**Stanislaus County Final ISMND Package
Response to Comments Memo**

Subject: **Response to Comments**
Public Draft Initial Study/Mitigated Negative Declaration (IS/MND)
Well Permit Application Nos. 2021-69, 2021-70, 2021-71, 2021-72 and Two
Future Permits
Hunter Ranch, Stanislaus County, California

Figure 9
Maximum Predicted Extent of Drawdown Exceeding 5ft (Scenario A)

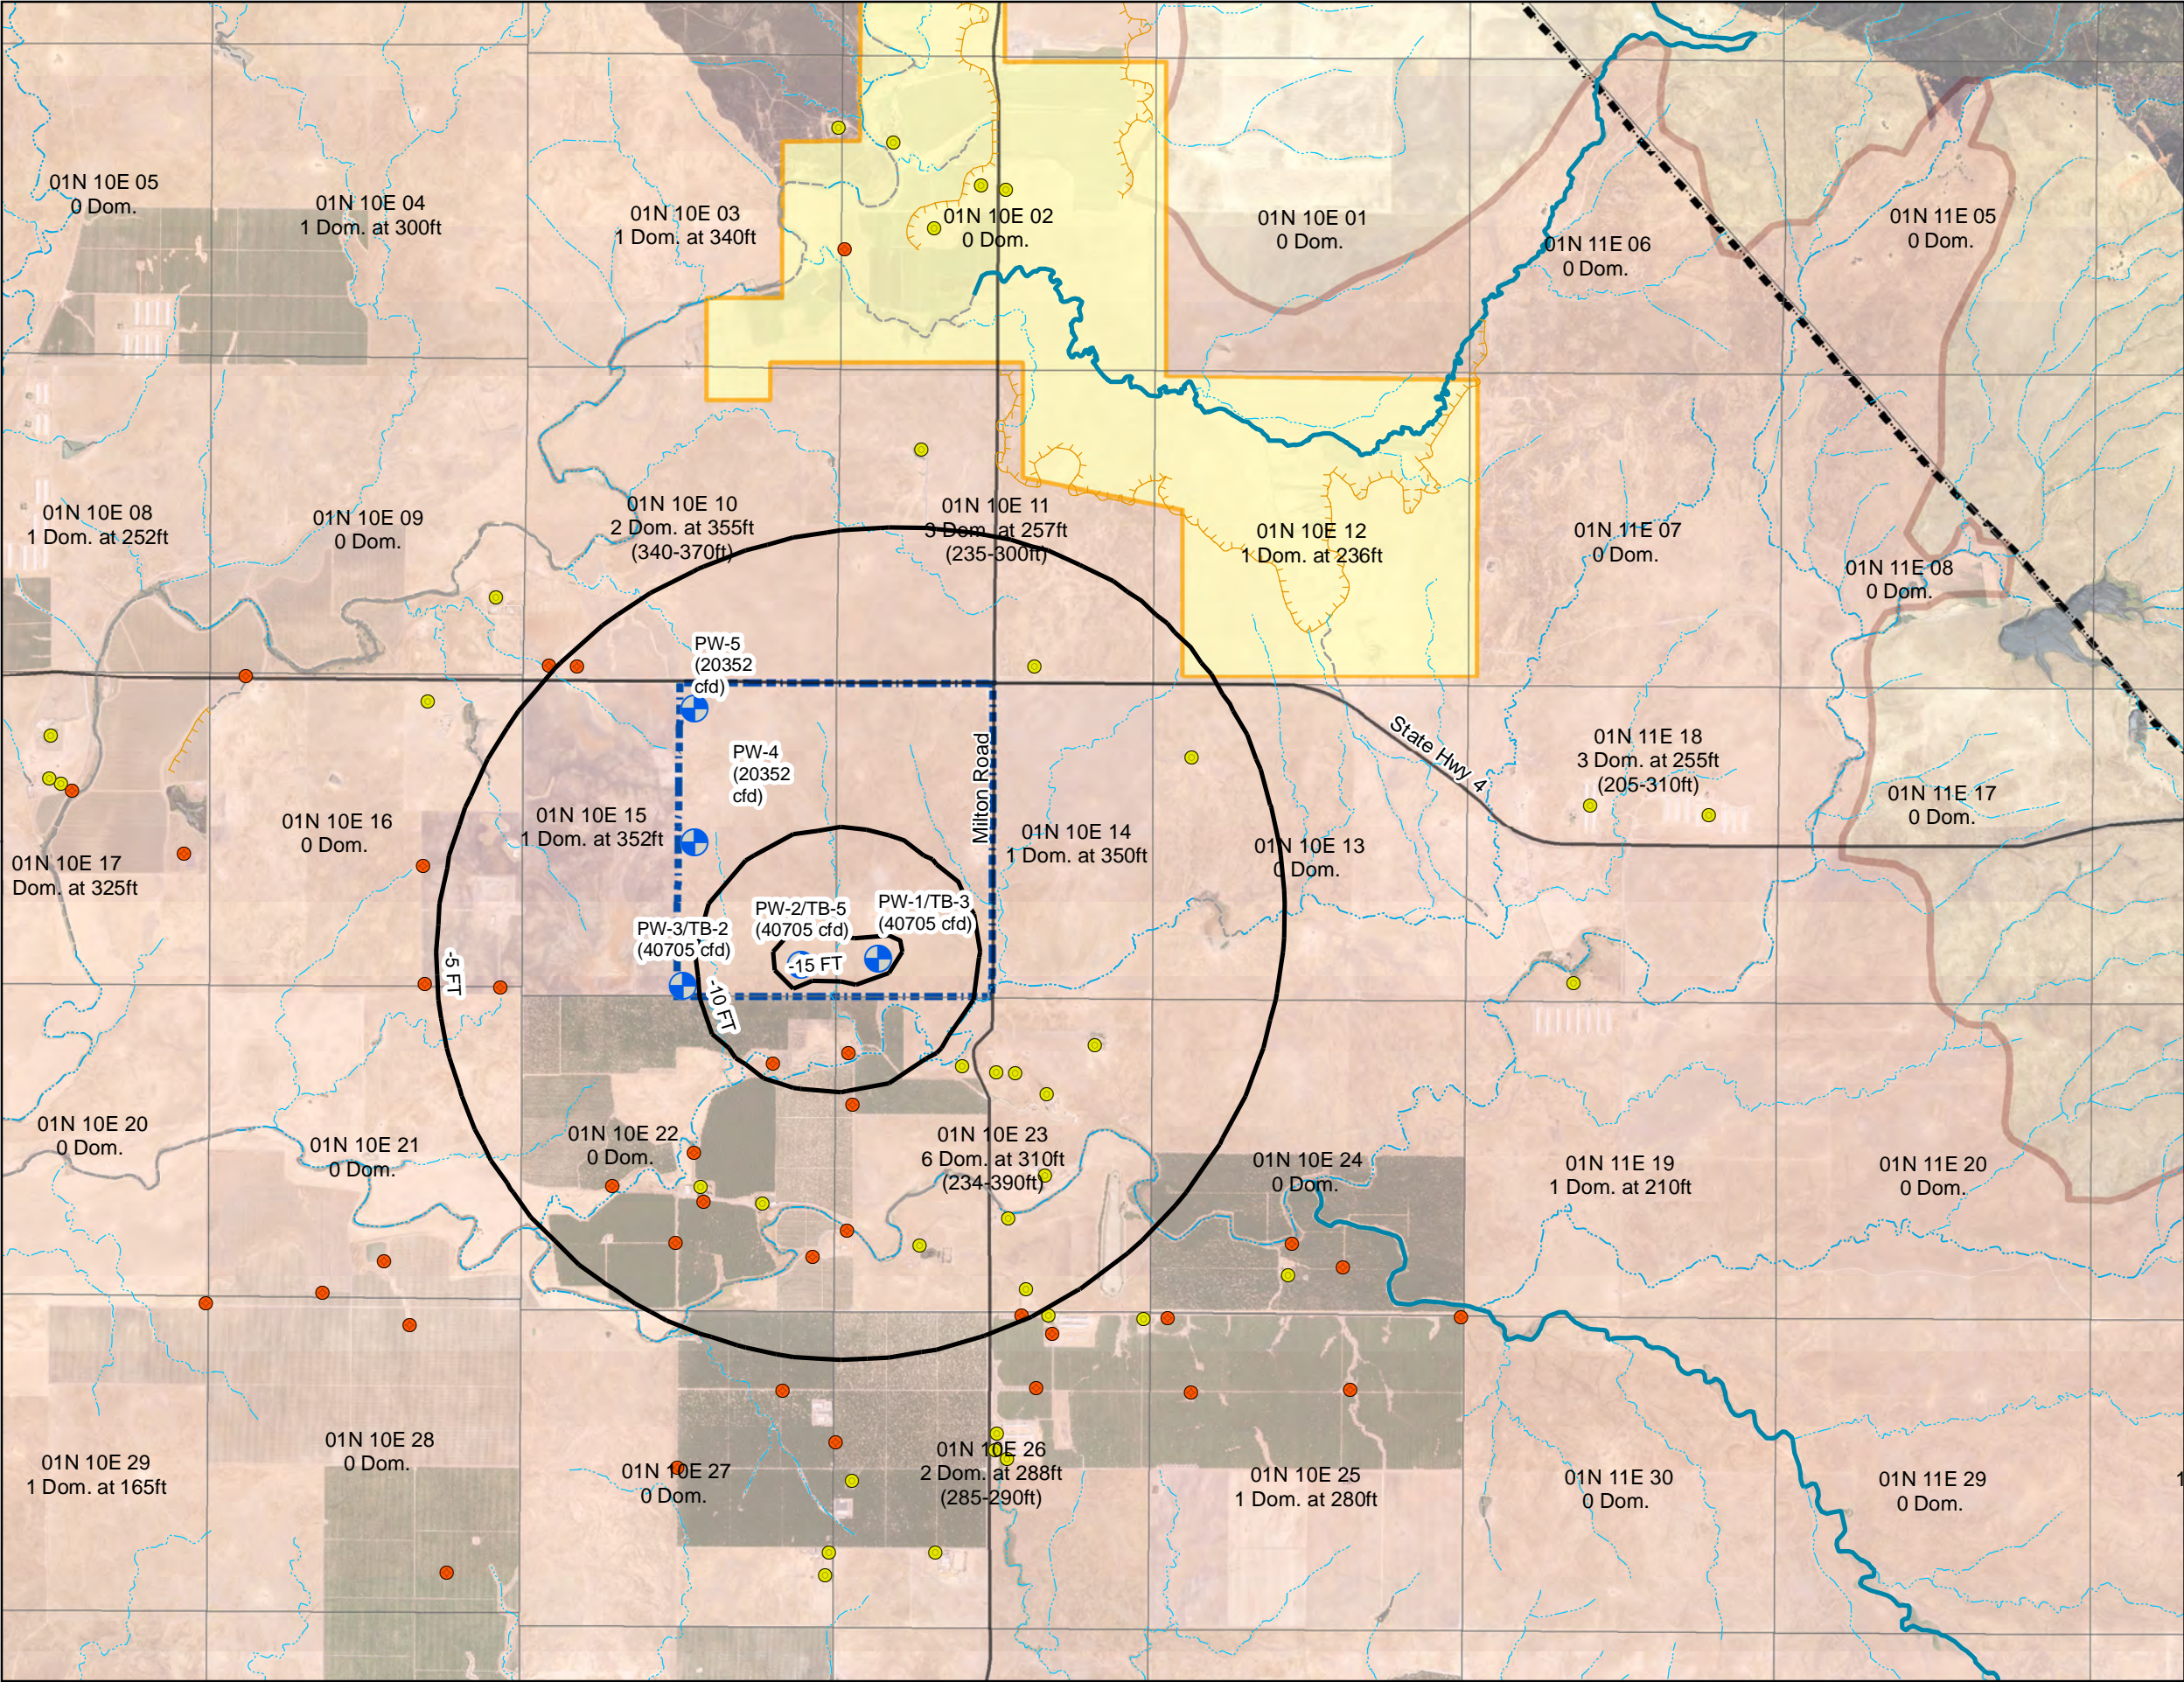
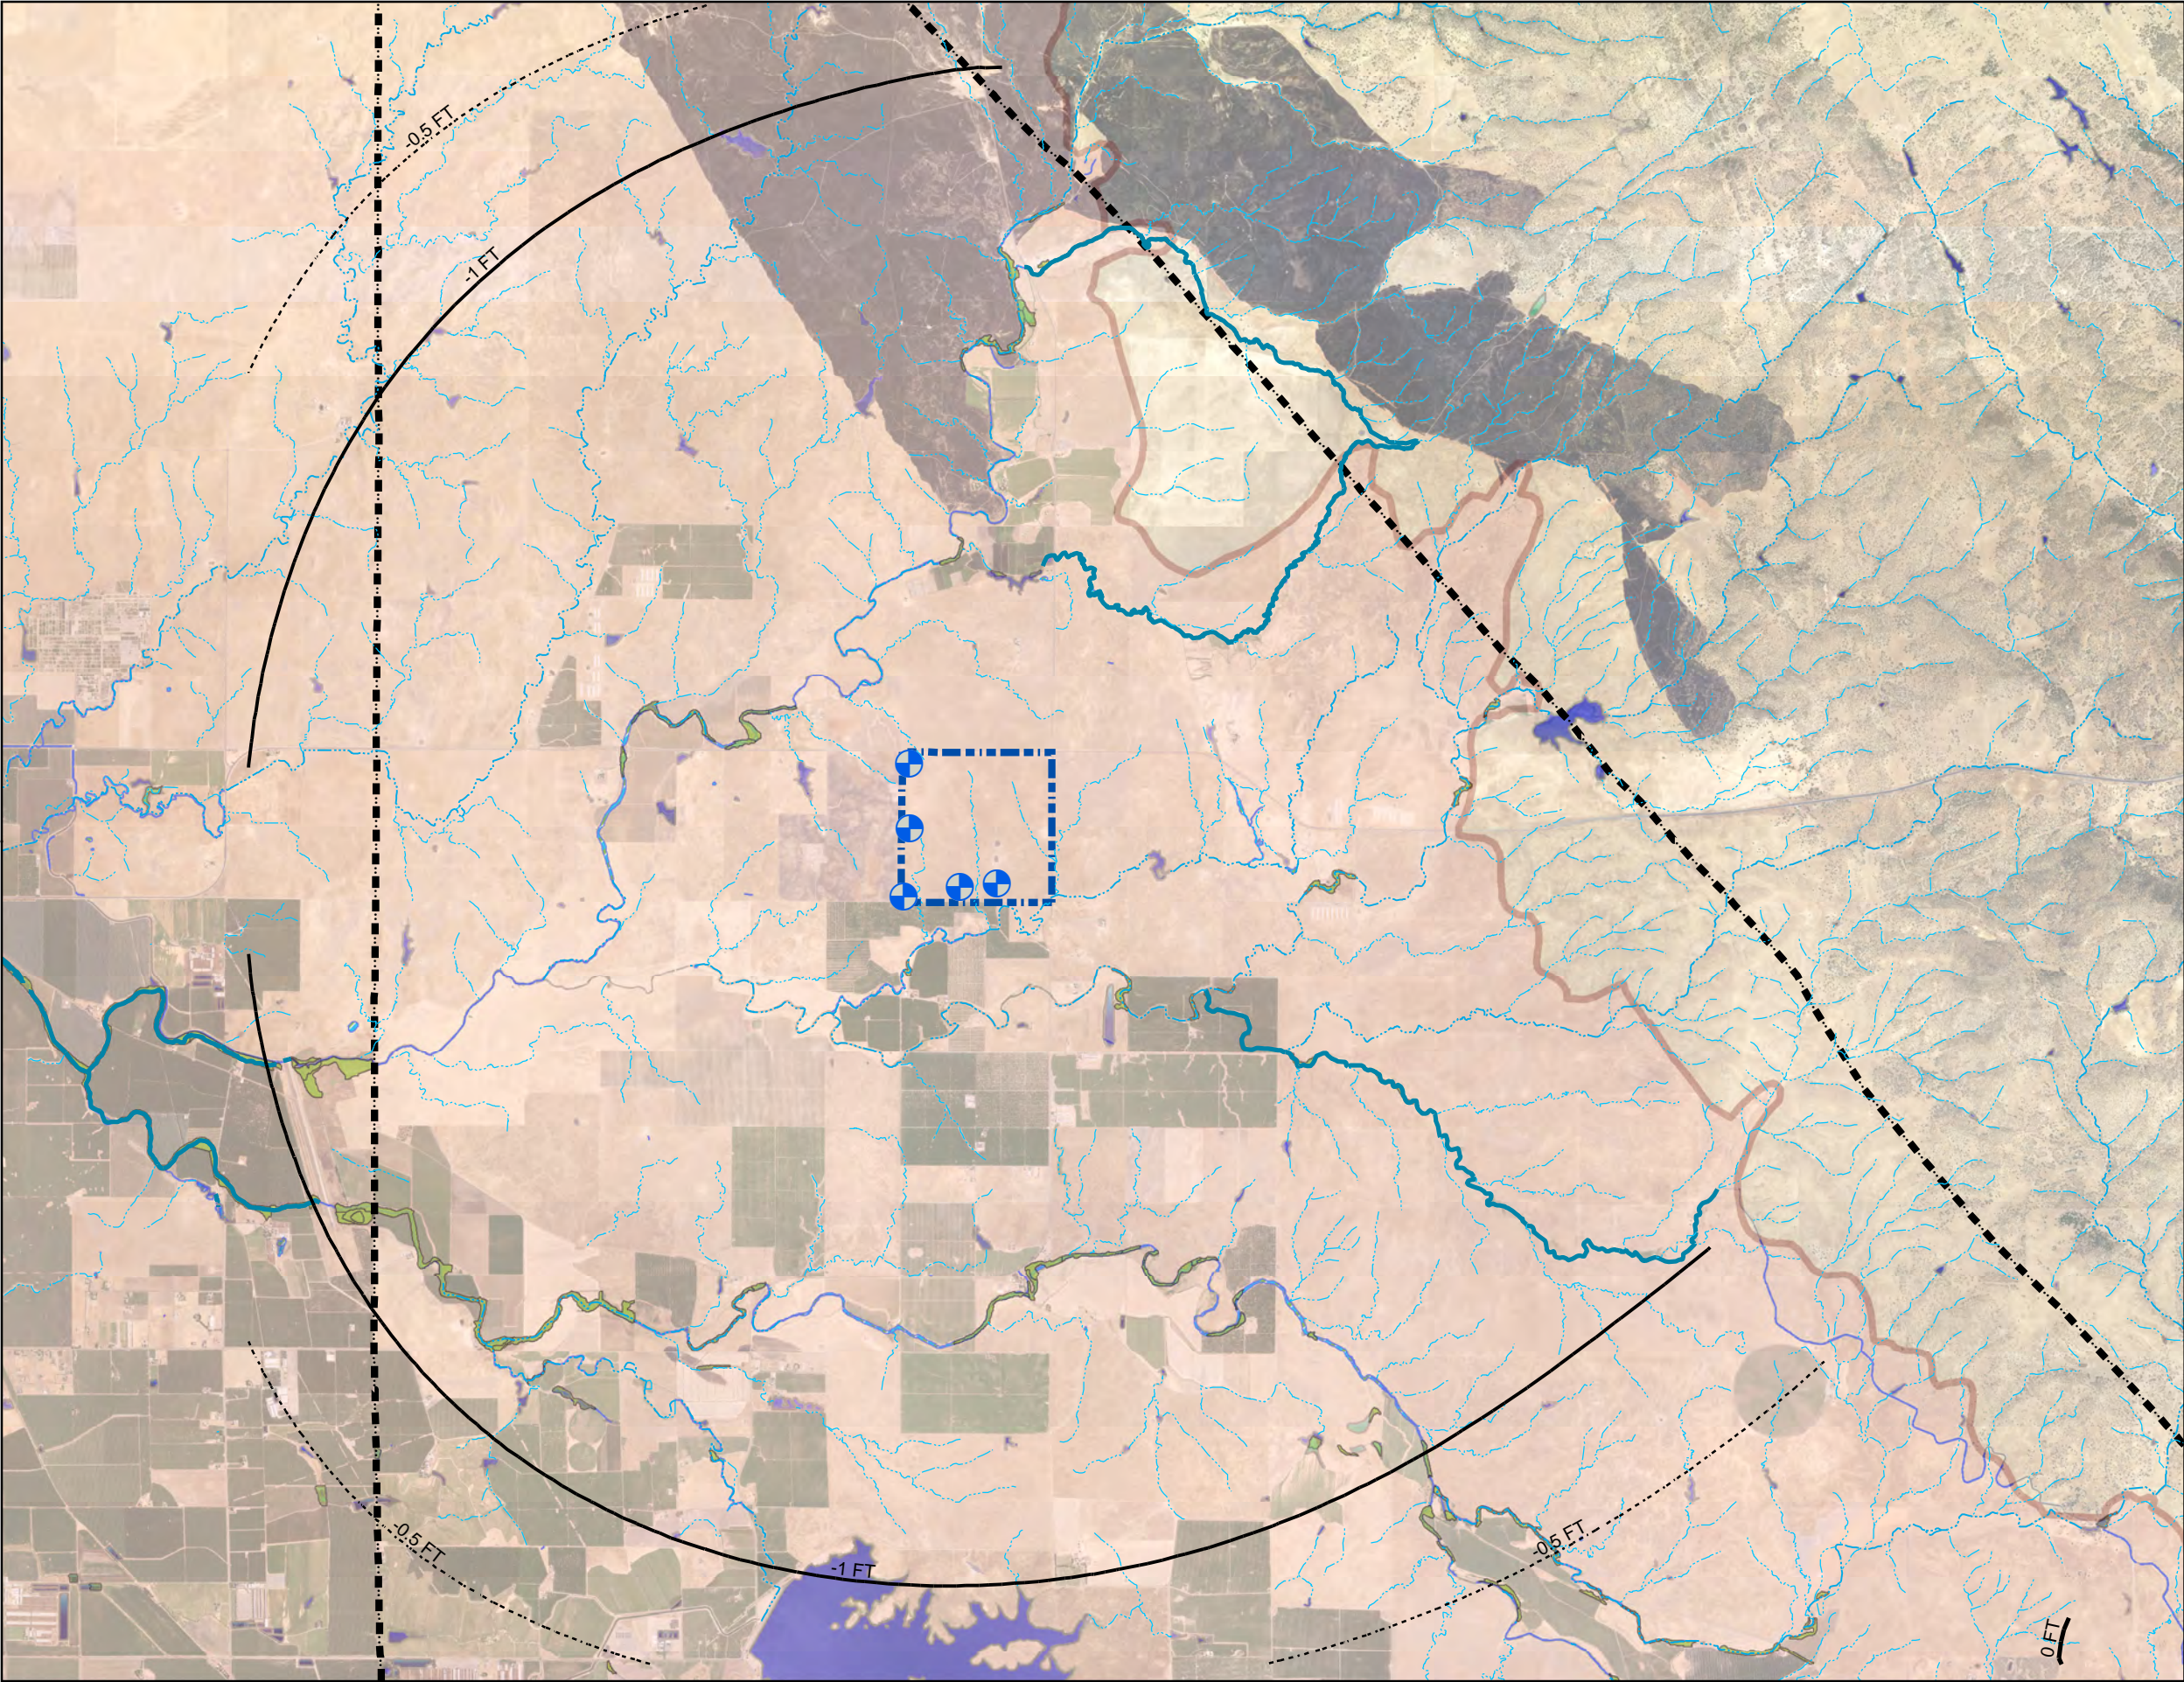
- The location of the Hatler Ranch well (the commenter’s well) is believed to have been identified as approximately 3,900 feet north of Highway 4 and 1,200 feet east of Milton Road, as shown on Figures 7 to 10 of the GRIA. As shown on Figure 7, the predicted drawdown at this well after 20 years of pumping under Phase 1 is approximately 4 feet, and the predicted drawdown from combined Phase 1 and Phase 2 pumping is approximately 8 feet (if Phase 2 pumping is initiated). The Hatler Ranch well is reported to be approximately 300 feet deep, so based on an estimated depth to groundwater of approximately 150 feet, the predicted Project drawdown would represent less than 10% of the available drawdown for this well. This amount of drawdown is unlikely to result in an observable reduction in pumping capacity; therefore, the potential impacts to the Hatler Ranch Well is expected to be less than significant.

- The locations of known domestic wells in the area are shown in the GRIA Figure 10, based on information obtained from the Department of Water Resources (DWR), review of aerial imagery and field observations from public roadways. The number and depth statistics for domestic wells for which the DWR has records are also shown on this figure, including both reported active wells and wells that are no longer being used or have been abandoned. The potential impacts from the Project pumping on domestic wells is discussed in the GRIA (pages 19 and 20, and 22 to 25). This analysis provides substantial and sufficient evidence to support assessment of the potential drawdown impacts from the Project to domestic wells and the conclusion that interference drawdown impacts to domestic wells will be less than significant.
